BID FOR: Jefferson Parish Dept. of Public Works
Maplewood Drive/Paillet Street Drainage Improvements
Public Works Proj. No. 2009-063-DR
Bid Proposal Number 50-00112110

TO: ALL PLAN HOLDERS OF RECORD

This Addendum, including all written and graphic attached data, forms a part of the Contract Documents and modifies, interprets, and amends the original drawings and specifications as issued for bid, as dated November 5, 2014, and as modified (if at all) prior to issuance of this Addendum.

JEFFERSON PARISH DEPT. OF PUBLIC WORKS
 MAPLEWOOD DRIVE/PAILET STREET
 DRAINAGE IMPROVEMENTS
 16" WATERMAIN SCHEMATIC

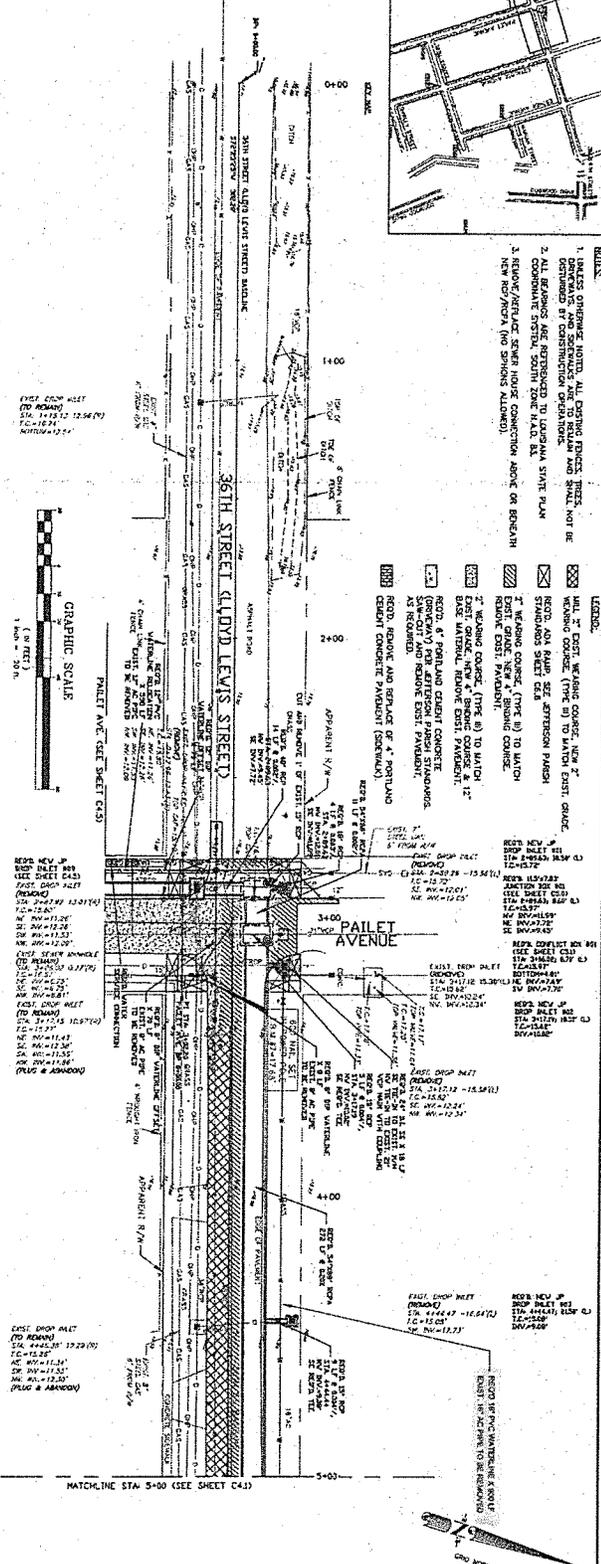
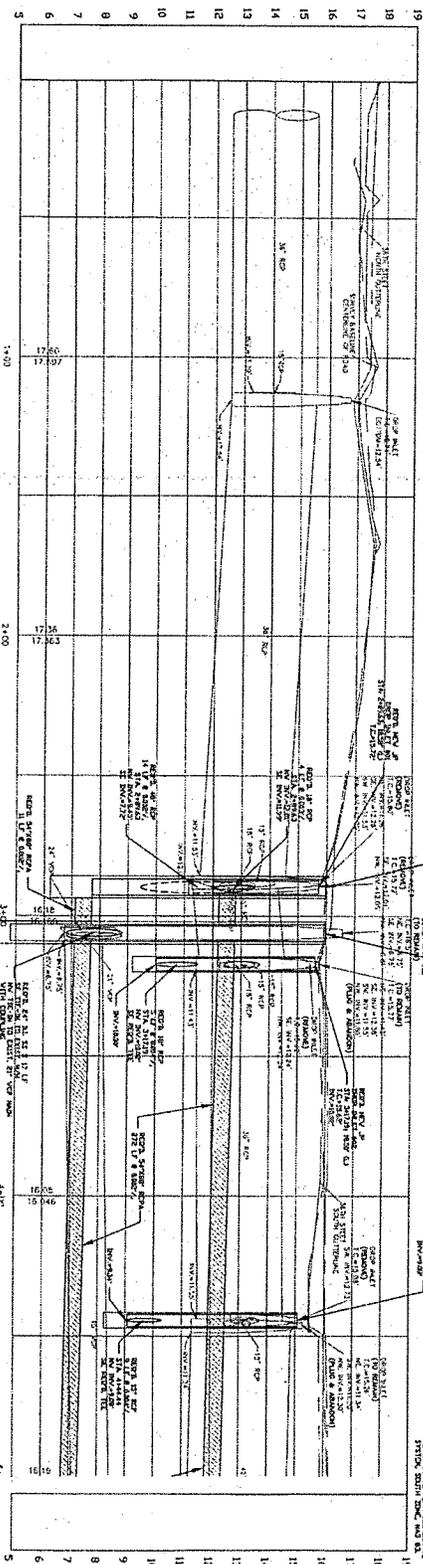
40. Add the following plan sheets which are attached as part of this Addendum No. 2: Sheet No. W-1, 16" Water Main Schematic; Sheet No. W-2, 16" Water Main Schematic; Sheet No. W-3, 16" Water Main Schematic. These sheets are to be used only for installation of the 16" water main; all other details on these sheets shall be super ceded by Plan-Profile Sheets C-4.0, C-4.1, and C-4.2 respectively.
